MIL-PRF-19500/795
w/AMENDMENT 1
25 February 2026
SUPERSEDING
MIL-PRF-19500/795
16 May 2025

PERFORMANCE SPECIFICATION SHEET

TRANSISTOR, FIELD EFFECT RADIATION HARDENED, N-CHANNEL, SILICON, TYPES 2N7645, QUALITY LEVELS JANTXV AND JANS

* FIGURE 2. Dimensions and configuration (Similar to SMD-0.2), with ceramic lid (U8CE).

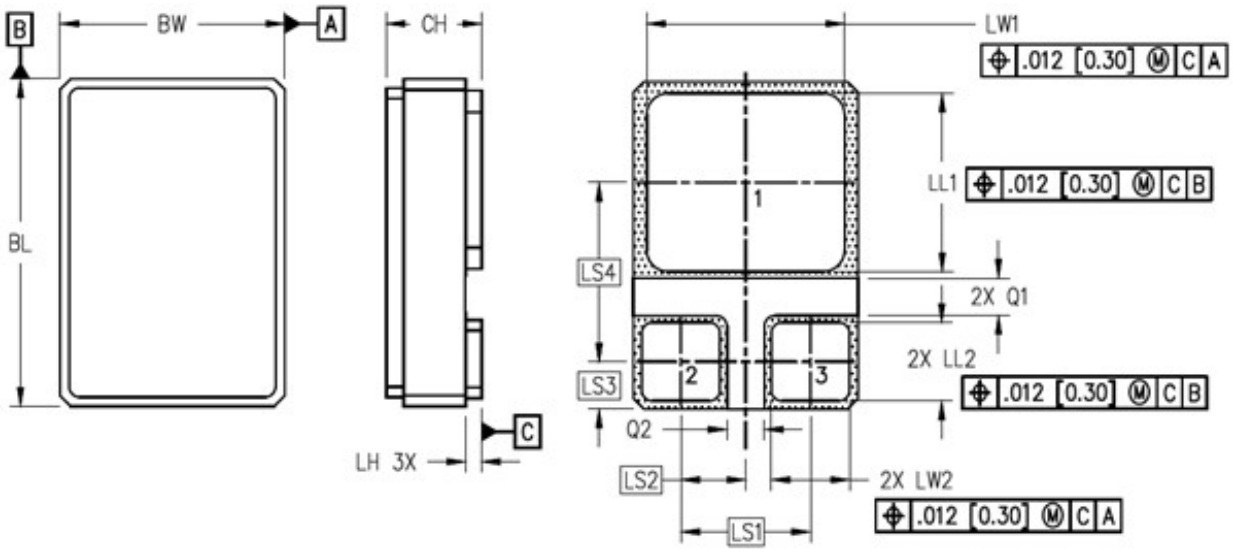
* 1.2 Package outlines. The device package outlines are as follows: surface mount SMD-0.2, U8C (ceramic lid) suffix in accordance with figure 1, surface mount SMD-0.2, U8CE (ceramic lid) suffix in accordance with figure 2, for all encapsulated device types.

U8C	Indicates a ceramic lidded 3 pad surface mount package (SMD-0.2) (see figure 1).
U8CE	Indicates a ceramic lidded 3 pad surface mount package with enhanced PCB mount features, similar to a SMD-0.2 (see figure 2)

* 3.4 Interface and physical dimensions. Interface and physical dimensions shall be as specified in MIL-PRF-19500, and on figure 1 (SMD-0.2, U8C), and figure 2 (Similar to SMD-0.2, U8CE) herein.

Symbol	Dimensions			
	Inches		Millimeters	
	Min	Max	Min	Max
BL	.300	.310	7.62	7.87
BW	.205	.215	5.21	5.46
CH		.097		2.46
LH	.010	.020	0.25	0.51
LW1	.180	.190	4.57	4.83
LW2	.068	.078	1.73	1.98
LL1	.161	.171	4.09	4.34
LL2	.068	.078	1.73	1.98
LS1	.121 BSC		3.07 BSC	
LS2	.061 BSC		1.55 BSC	
LS3	.044 BSC		1.12 BSC	
LS4	.167 BSC		4.24 BSC	
Q1	.030		0.76	
Q2	.030		0.76	
TERM 1	Drain			
TERM 2	Gate			
TERM 3	Source
